Nomad SERVICE BULLETIN

TRANSMITTAL LETTER
FOR
SERVICE BULLETIN NMD-21-1

AIR CONDITIONING - DISTRIBUTION — PLENUM CHAMBER FLAPPER VALVE ASSEMBLY REPLACEMENT (MOD N774)

AIR CONDITIONING - DISTRIBUTION - PLENUM CHAMBER FLAPPER VALVE ASSEMBLY REPLACEMENT (MOD N774)

Figure 1 Flapper Assembly — Manufacture

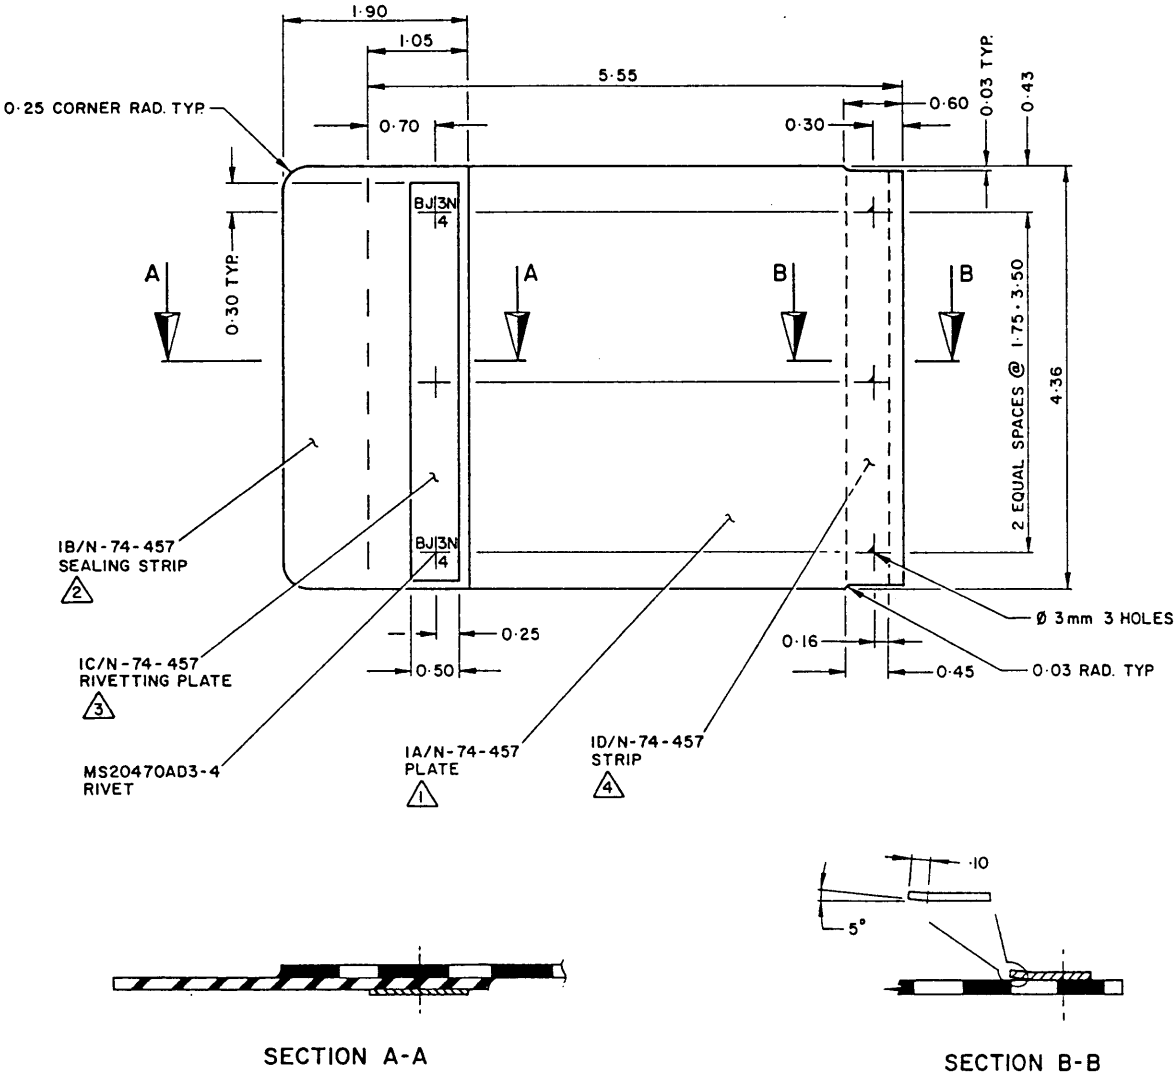
A new Flapper Assembly PN 1/N-74-457 is manufactured and installed in lieu of Flapper Assembly PN 1/N-74-409. The flapper plate is increased in thickness from 0.040 to 0.080 in and a 0.040 in thick reinforcing strip added.

- (1) Manufacture Plate PN 1A/N-74-457.
- (2) If available, use a superseded Plate PN 1A/N-74-409 to back-drill the three holes in the strip and the three rivet holes in the plate. If not refer to Figure 1. Deburr all edges and holes.
- (3) Alodine plate and epoxy prime (one coat).
- (4) Manufacture Sealing Strip PN 1B/N-74-457. Use Plate PN 1A/N-74-457 as a template to cut three sealing strip holes.
- (5) Bond sealing strip to plate using Araldite AW106/HV953U (Ref Fig 1 Sect A-A).
- (6) Manufacture Riveting Plate PN 1C/N-74-457. Deburr all edges and holes.
- (7) Alodine plate and epoxy prime (one coat).
- (8) Rivet riveting plate to flapper assembly (Ref Fig 1 Sect A-A).

- (9) Manufacture Strip PN 1D/N-74-457 (Ref Fig 1).
- (10) Bond strip to flapper plate using Araldite AW106/HV9534. Ensure holes in strip are aligned with flapper plate holes.

NOTES:	1. MAKE FROM	0.080 x 4.36 x 5.65	ALUMINIUM ALLOY	QQ-A-250/5
	2. MAKE FROM	0.062 x 1.90 x 4.36	ACRYLONITRILE BUTADIENE RUBBER	BS 2751
	3. MAKE FROM	0.020 x 0.50 x 4.10	ALUMINIUM ALLOY	QQ-A-250/5
	4. MAKE FROM	0.040 x 0.45 x 4.30	CRES	MIL-S-6721
